Office Action Summary

10/587,779

THELWELL, GORDON

DETAILED ACTION

Annotated Figure 2

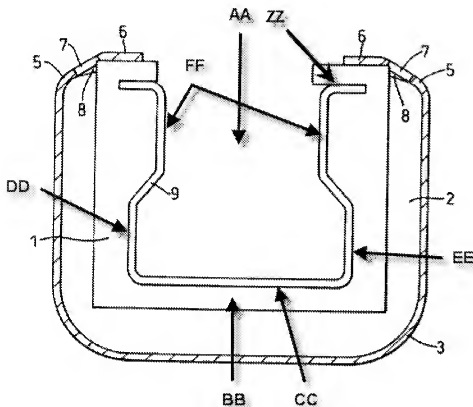
Regarding **Claim 61**, Ian teaches; **Claim 61** - a column protecting device (3) for protection of an upright column (9) of a racking system, (Figure 3); wherein the column (9) has a channel shaped cross section (AA) having a substantially rectangular front portion (BB) consisting of a front member (CC), and a first (DD) and second (EE) side member, (Annotated Figure 2 Below); the column protector device (3) being arranged to clip onto the upright column (9), (Figure 2 and Page 4, Lines 10-14); the protector device further comprises a rigid, substantially part cylindrical "C" shaped cross section outer shell (3), and an inner liner (1 and 2) shaped to fit within the outer shell (3), (Figure 2 and Page 3, Lines 3-8 of the specification); wherein the outer shell (3) is capable of fitting around the upright column so that the outer shell (3) retains to the column (9) without further fixtures, (Figure 2 and Page 4, Lines 10-14); the outer shell

(3) also surrounds the front member (CC) and partially surrounds (does not surround the tips labeled as ZZ) the first (DD) and second (EE) side members, (Annotated Figure 2 Below); the inner liner (1 and 2) being retained between the outer shell (3) and the column (9), (Figure 3); the inner liner (1 and 2) comprises a solid substantially part cylindrical member having a substantially part cylindrical outer surface (the outer corners of (2) are rounded and the inner liner is therefore part cylindrical), the inner liner (1 and 2) also having a substantially "U" shaped channel (the inner surface of the liner (1) touching the upright column (9)) formed on an opposite side of said inner liner to said substantially part cylindrical outer surface and in which, in use, said channel provides for a flush interface between the inner liner (1 and 2) and the upright column (9), (as seen in Figure 2); **Claim 62** – wherein each of the first and second side members (DD and EE) comprises an outer (DD and EE) and an inner side member (FF), (Annotated Figure 2 Below); the outer shell (3) when fitted to the column (9) surrounds the front member (CC) and said first and second side members (DD and EE), thereby protecting them, (Annotated Figure 2); the outer shell (3) partially surrounds the first and second inner side members (FF) so that the exposed upright edges (the end edges near item (6) in Annotated Figure 2) of the outer shell (3) lay adjacent to the sides of the column at a position where the column is relatively narrower, (Annotated Figure 2 Below); **Claim 63** – wherein, in use, the column (9) resides partially within a channel formed by the outer shell (3), (Figure 2); **Claim 64** – wherein said outer shell (3) comprises an elongate member having a substantially "C" shaped cross section, (Figure 2); **Claim 80** – wherein said inner liner (1 and 2) is capable of, after receiving an impact,

the inner liner (1 and 2) promotes the repositioning of the whole device to an original shape before the impact occurred, (Figure 2 and Page 4, Lines 3-8); **Claim 81** - the outer shell (3) surrounding the front member (CC) and partially surrounding (does not surround the tips labeled as ZZ) the first (DD) and second (EE) side members, and also surrounding the inner liner (1 and 2), which rests between a substantially part cylindrical inner surface of the outer shell (3) and an outer face of the front member (CC), an outer face of the first side member (DD) and second side members (EE), (Annotated Figure 2 Below); **Claim 82** - the inner liner and outer shell being slideable with respect to each other along a central axis of the outer shell, (Page 1, Lines 24-28); **Claim 83** - the outer liner and an inner liner being bonded together, (Page 2, Lines 1-5); **Claim 86** - the outer shell and the inner liner composed of polycarbonate and foam (Page 2, Line 8 and Page 2, Lines 6-7); both materials having greater ductility, and impact resilience then the shelving which is made from metal (Page 1, Lines 12-14); **Claim 87** - teaches the device being "capable of" fitting around the upright column so that the outer shell (3) retains to the column (9) without further fixtures, (Figure 2 and Page 4, Lines 10-15).

Annotated Figure 2, Version #2 (lan)

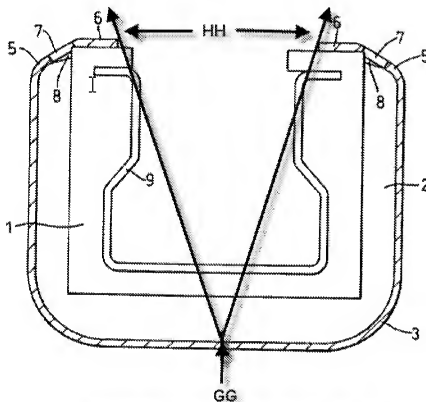
Regarding **Claim 65**, **Ian** teaches the outer shell (3) comprising a tubular part cylindrical member (3), (Figure 3); wherein the tube has a pair of substantially parallel opposing edges (the end edges near item (6) in Annotated Figure 2, Version #2 Below) on either side of a gap, (Figure 2). **Ian** does not teach the cylindrical member extending over an angle in the range of 260 to 280 degrees, but **Ian** does teach a range (HH) about a longitudinal centre line (GG) of the outer shell (3) which is very similar to the claimed range, (Annotated Figure 2, Version #2 Below). Therefore, the examiner points to case law *In Gardner v. TEC Systems, Inc.*, 725 F.2d 1338, 220 USPQ 777 (Fed. Cir. 1984), *cert. denied*, 469 U.S. 830, 225 USPQ 232 (1984). The court found that if the only difference between the prior art device and the claims was a recitation of relative dimensions and a device having those claimed dimensions would not perform differently than the prior art device, the claimed device was not patentably distinct from the prior

art device (See MPEP 2144). It would have been obvious to one of ordinary skill in the art to modify the prior art device of **lan** to have the cylindrical member extending over an angle in the range of 260 to 280 degrees for the purpose of user design as it would not cause the device to perform differently.
